Well Name: JICARILLA 390 B	Well Location: T23N / R4W / SEC 26 / NWSW /	County or Parish/State: SANDOVAL / NM
Well Number: 1	Type of Well: CONVENTIONAL GAS WELL	Allottee or Tribe Name: JICARILLA APACHE
Lease Number: JIC390	Unit or CA Name:	Unit or CA Number:
US Well Number: 3004320694	Well Status: Producing Gas Well	Operator: DJR OPERATING LLC

Notice of Intent

Plug and Abandonment Procedure
for
DJR Operating, LLC
Jicarilla 390 B 1
API # 30-043-20694
NW/SW, Unit L, Sec. 26, T23N, R4W
Sandoval County, NM

CONDITIONS OF APPROVAL

Proposed PxA
DJR Operating, LLC
Jicarilla 390 B 1
API # 30-043-20694
NW/SW, Unit L, Sec 26, T23N, R4W
Sandoval County, NM

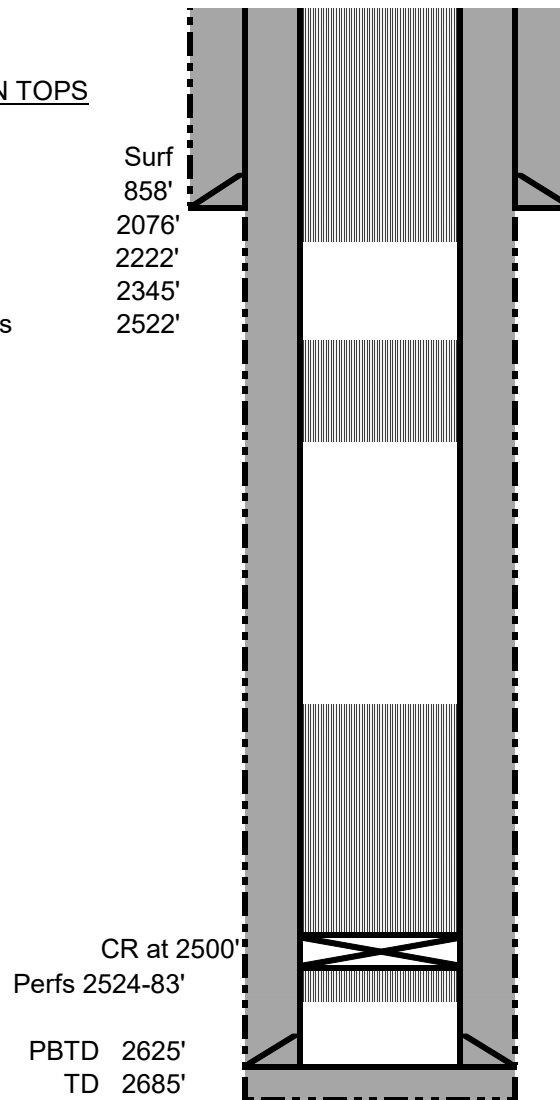
You are also required to place cement excesses per 4.2 and 4.4 of the attached General Requirements.
